# US 2 Profile Change

(Preliminary Subject to Revision)

## North Spokane Corridor Project Groundwater Assessment: Farwell and US 2 Interchange

### Perched Groundwater

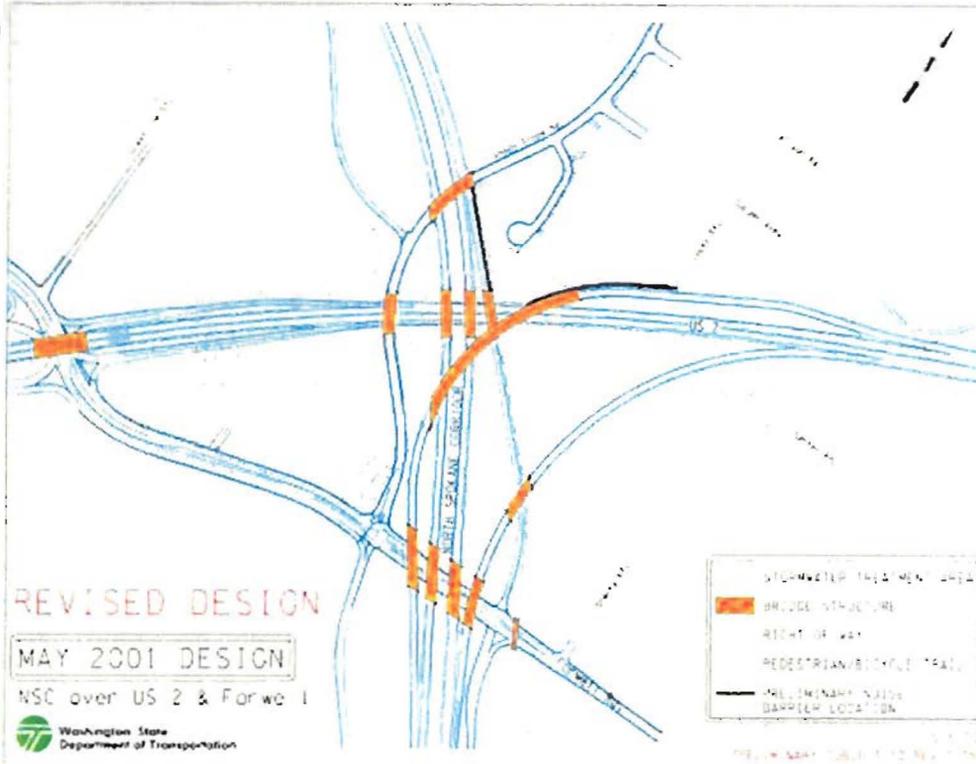
The original profile configurations of US 2 and the NSC in the vicinity of Shady Slope Road have been revised to accommodate several areas of perched groundwater. Perched groundwater occurs when water in the ground is trapped on top of a semi-permeable or impermeable surface which is higher than the normal groundwater level in the surrounding area.

Geotechnical investigations determined that several perched water tables would be affected under the original profile configuration where the NSC was depressed as it passed under US 2. In this situation, water migrating into the depressed freeway section posed a significant drainage problem since the water would collect in the lowered section. To mitigate this problem, the profiles were revised to have the NSC pass over a lowered US 2 roadway. This design will allow groundwater that flows into the lowered US 2 section to flow along the natural drainage course to a water quality treatment pond prior to entering Deadman Creek.
